## **GROVE FARM**

**TRANSPORTATION & HIGHWAY  
SUPPLEMENTARY REPRESENTATIONS No.3**

**HIGHWAYS ENGLAND  
DEVELOPMENT CONSENT ORDER APPLICATION (DCO)  
FOR  
M25, JUNCTION 28 IMPROVEMENT SCHEME**

**Redwood Reference: PMcL/3396d4/April 2021**

**Fig 3.1 - HE Indicative alignment of amended Grove Farm egress (Change 8)**

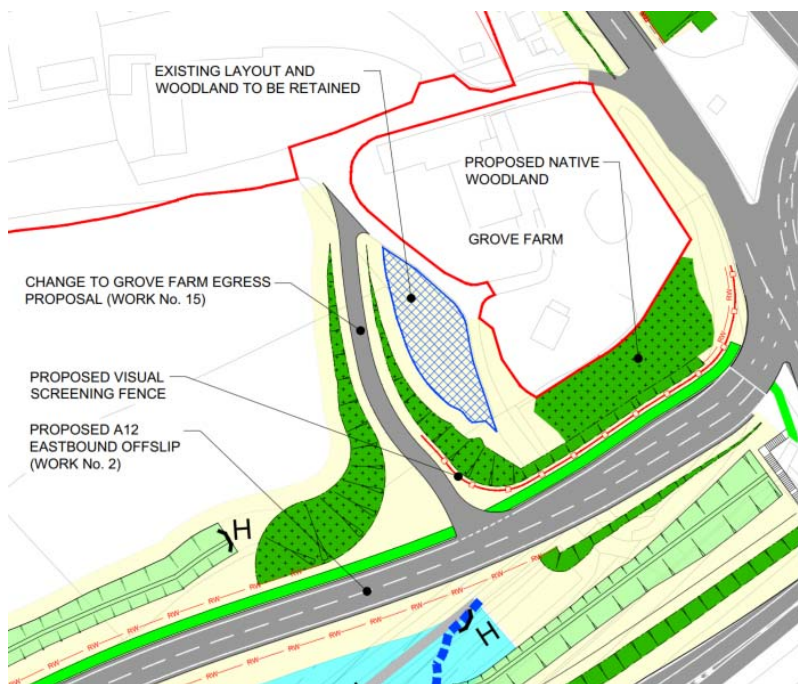
3.2 Grove Farm welcomes the response from HE with regards alteration of the farm egress onto the A12 eastbound off-slip, however a number of concerns remain:

- i) Proposals for Change 8 should be developed with Grove Farm on a topographical survey base not an ordnance survey base so that the full impact of proposals can be adequately reviewed. The request for topographical survey plans have previously been made;
- ii) The Change 8 proposals identify a 'visual screening fence' along the boundary of the A12 eastbound off-slip. Grove Farm's Supplementary Representations No.2, Section 4.0 (Ref: PMcL/3396d3/April 2021) discussed the reasons why a 'visual

- screen' is not acceptable to Grove Farm. The Scheme provides the only opportunity to enhance the environment of Grove Farm and partially mitigate the detrimental effects of the Scheme on Grove Farm. The provision of a noise attenuation barrier instead of a 'visual screen' fully supports HE's own goal to enhance the environment for people living and working close to the HE network and not just retain a detrimental status quo;

- iii) The proposed 'visual screen' will be up to 3m high. This structure will require significant footings in any event and an upgrade is a cost issue. The ExA should direct HE to upgrade the visual screen to a noise attenuation barrier;

**Figure 3.2 – Grove Farm's suggested location for extra noise attenuation fencing**

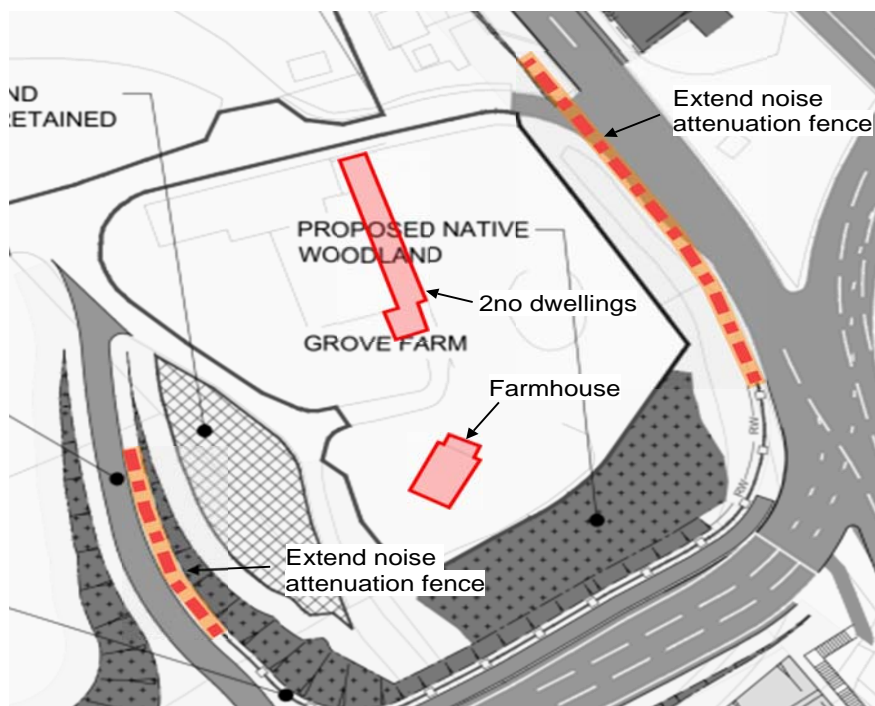
- vi) The new location of the Grove Farm access will relocate industrial traffic further away from the third dwelling located at the existing site access, improving the amenity of that dwelling;
- vii) The closure of the existing farm access will allow for a noise attenuation barrier to be extended further north mitigating growing traffic noise effects on all three dwellings on the site from the M25 and the M25 northbound slip-on (see section 3.2 iv);
- viii) Further drawings issued by HE should highlight all three residential dwellings on the site (**Fig 3.2**).

- v) The re-alignment of the A12 eastbound on-slip will relocate traffic flows closer to existing dwellings. A noise attenuation barrier should be extended into the site at the site egress as shown on **Fig 3.2**:

- 3.3 In conclusion, Grove Farm requests that the ExA should direct the HE to provide a noise attenuation barrier instead of the 'visual screen' currently proposed and extend the noise attenuation barrier further north on the M25 northbound on-slip and further north into the farm egress as shown on **Fig 3.2**.
